Service Letter No. 419

SUBJECT: Inspection of Heater Air Distribution Box Attachment Screws

MODELS AFFECTED: PA-30 Twin Comanches, Serial Numbers 30-1 to 30-278 inclusive.

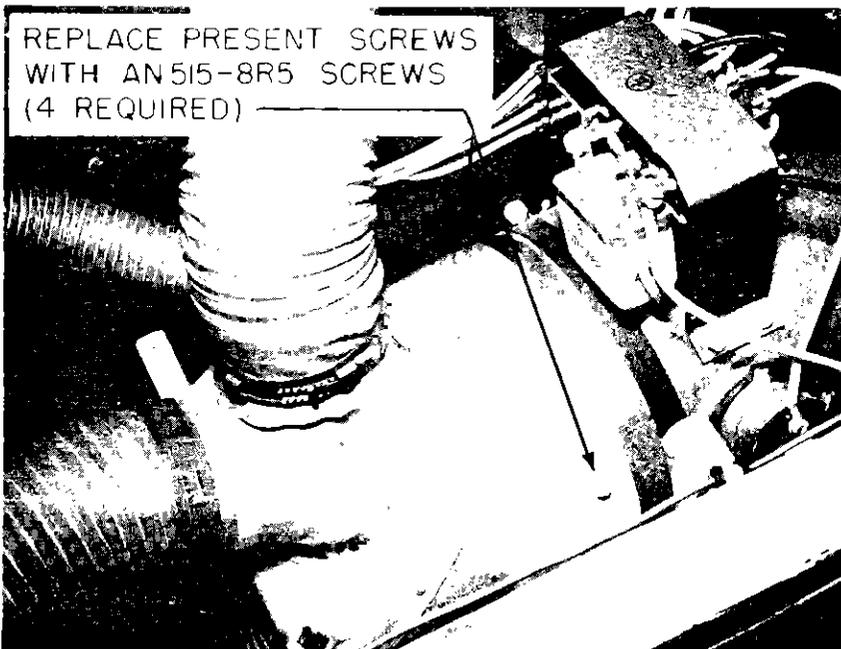
A report from the field has indicated that the heater air distribution box attachment screw in the subject aircraft may project through the heater outer shell far enough to contact the combustion chamber.

In order to correct this situation, the AN515-8R6 screw presently installed should be removed and replaced with an AN515-8R5 screw. See sketch on the reverse side of this letter.

The area of the heater combustion chamber directly under the four (4) screws should be checked for possible chafing at the time the screws are changed.
